22108243

FLOOR PLANS

6332

Cebra St

FIRST FLOOR PLAN
1/8" = 1'-0" (11x17)
1/4" = 1'-0" (22x34)

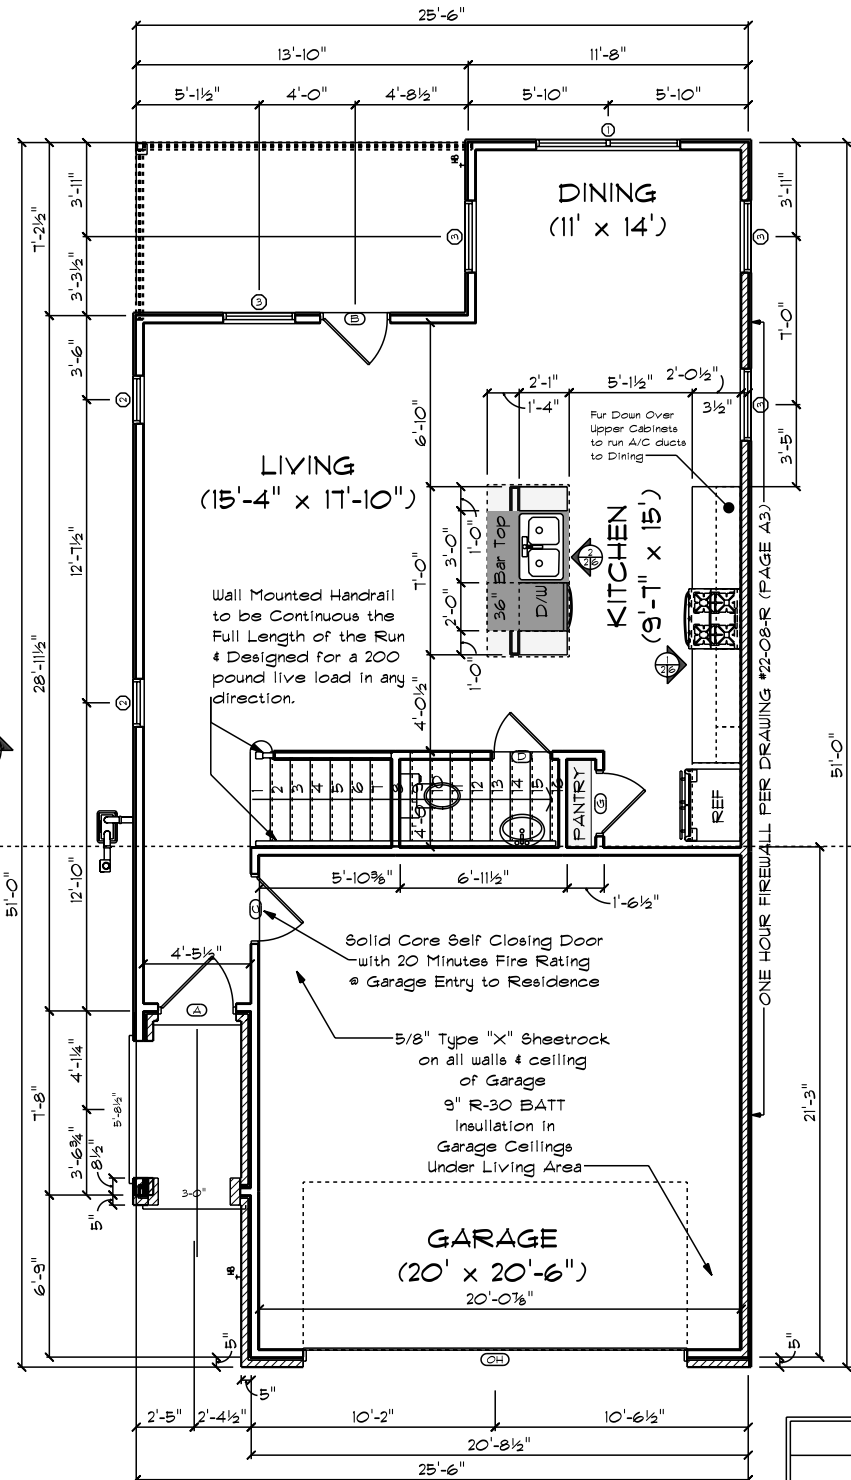
Windows (Sill Height) R312.2.1
In dwelling units where the opening of an operable window is located more than 12 inches above the finished grade or surface below, the lowest part of the clear opening of the window shall be a minimum of 24 inches above the finished floor of the room in which the window is located. Glazing between the floor and 24 inches shall be fixed or have openings through which a 4 inch diameter sphere cannot pass.

SECOND FLOOR PLAN
1/8" = 1'-0" (11x17)
1/4" = 1'-0" (22x34)

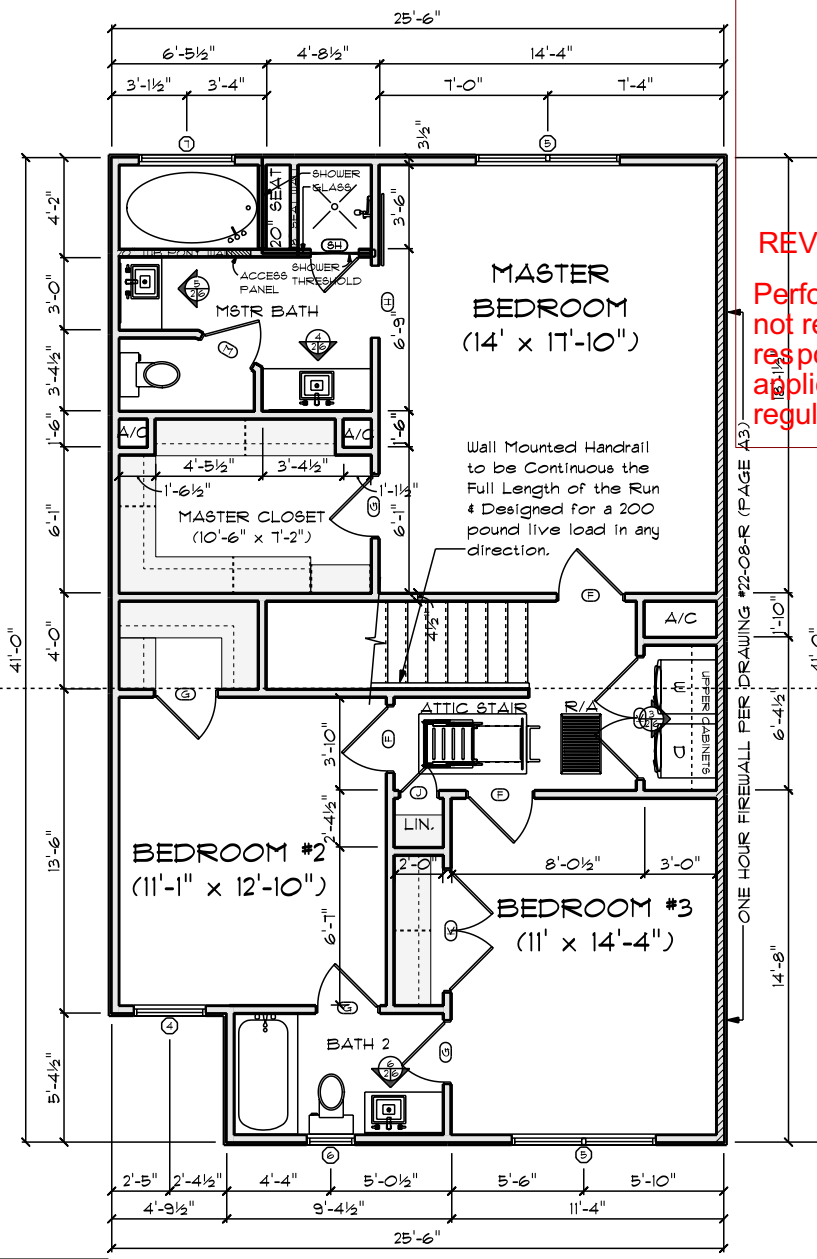
ACCESS STAIRWAY SHALL COMPLY WITH SECTION M1305.1.3 AS AMENDED BY HOUSTON. THE REQUIREMENTS HAVE BEEN REVISED AS SUCH. CONTAINING APPLIANCES REQUIRING ACCESS SHALL BE PROVIDED WITH AIRWAY WITH A CLEAR OPENING NOT LESS THAN 22-INCHES IN WIDTH HARDWARE, AND A LOAD CAPACITY OF NOT LESS THAN 350-POUNDS. AN A CLEAR AND UNOBSTRUCTED PASSAGEWAY LARGE ENOUGH TO ALLOW THE LARGEST APPLIANCE, BUT NOT LESS THAN 30-INCHES HIGH AND 30-INCHES NOT MORE THAN 20-FEET IN LENGTH WHEN MEASURED ALONG THE CENTERLINE PASSAGEWAY FROM THE OPENING TO THE APPLIANCE. PASSAGEWAY SHALL HAVE CONTINUOUS SOLID FLOORING IN ACCORDANCE WITH IBC 505.2.1.1; NOT LESS THAN 24-INCHES WIDE. A LEVEL SERVICE SPACE AT LEAST 30-INCHES DEEP AND 30-INCHES WIDE SHALL BE PRESENT ALONG ALL SIDES OF THE APPLIANCE WHERE ACCESS IS REQUIRED. THE CLEAR ACCESS OPENING DIMENSIONS SHALL BE A MINIMUM OF 30-INCHES BY 54-INCHES WHERE SUCH DIMENSIONS ARE LARGE ENOUGH TO ALLOW REMOVAL OF THE LARGEST APPLIANCE.
